# SERVICE No. 905 BULLETIN

Piper Aircraft Corporation  
Vero Beach, Florida, U.S.A.

SUBJECT: Auxiliary Primer Switch Replacement

Figure 1

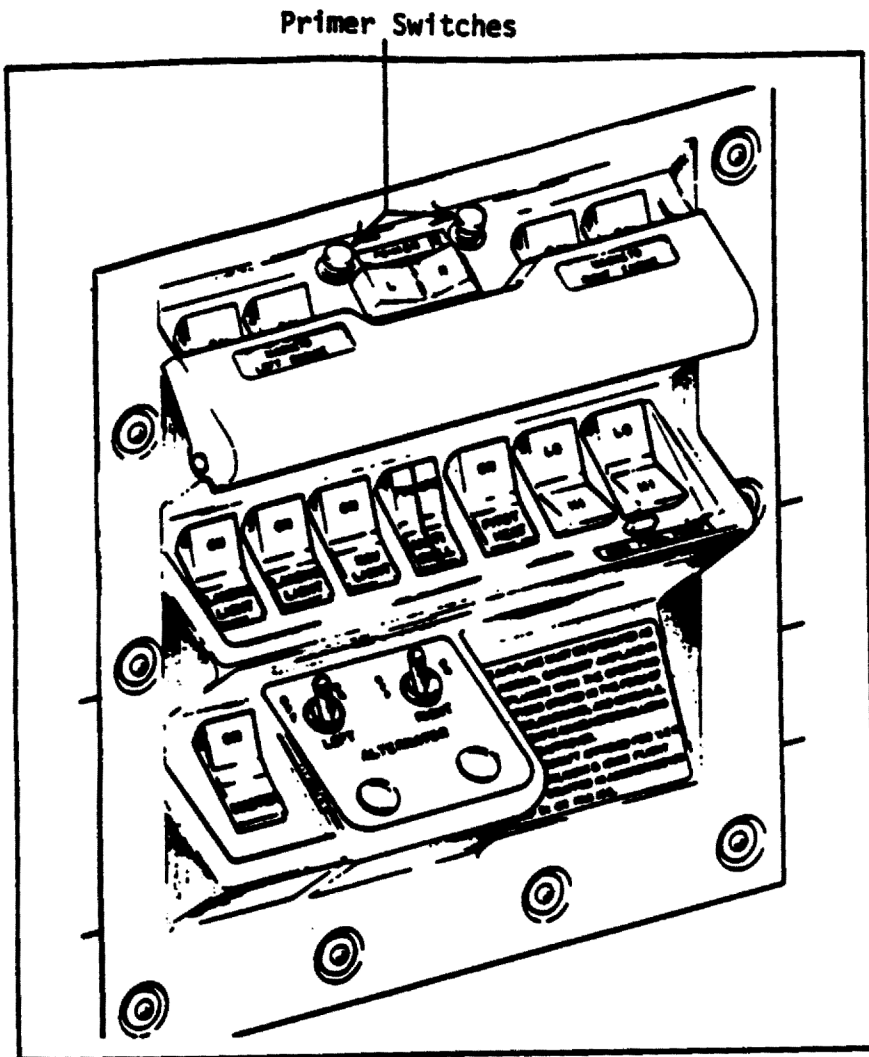
1. Disconnect the battery.
2. Locate the two auxiliary primer switch assemblies at the top of the switch panel to the left of the pilot's seat. See Figure 1 (attached).

Figure 2

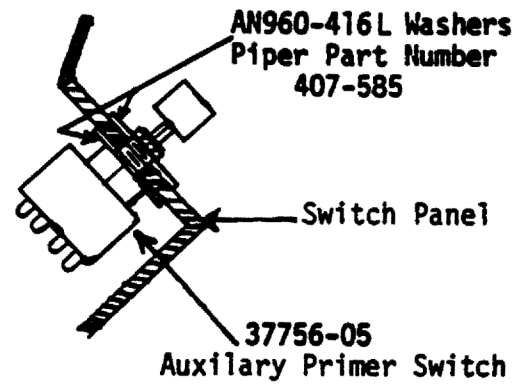
5. To install two new Auxiliary Primer Switch Assemblies, Piper Part Number 37756-05: Connect the electrical connectors. Secure in position using the hardware supplied with each new switch assembly plus two (2) each AN960-416L washer, Piper Part Number 407-585, per switch assembly as shown in Figure 2 (attached).

Figure 3

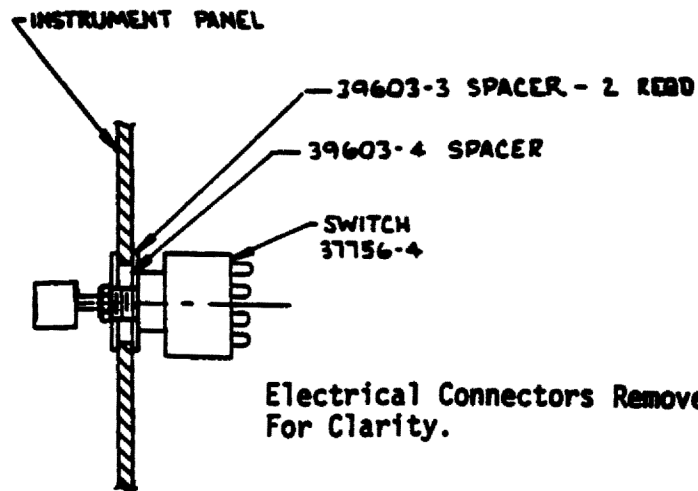
4. To install two new Auxiliary Primer Switch Assemblies, Piper Part Number 37756-04: Connect the electrical connectors. When positioning the switch assemblies in their mounting holes use two (2) each Spacer, Piper Part Number 39603-03 and one (1) each Spacer, Piper Part Number 39603-04 per switch assembly as shown in Figure 3. Secure with the hardware supplied with each switch assembly.
5. Connect the battery.
6. Perform a functional check of the primer system.
7. Make an appropriate logbook entry of compliance with this Service Bulletin.
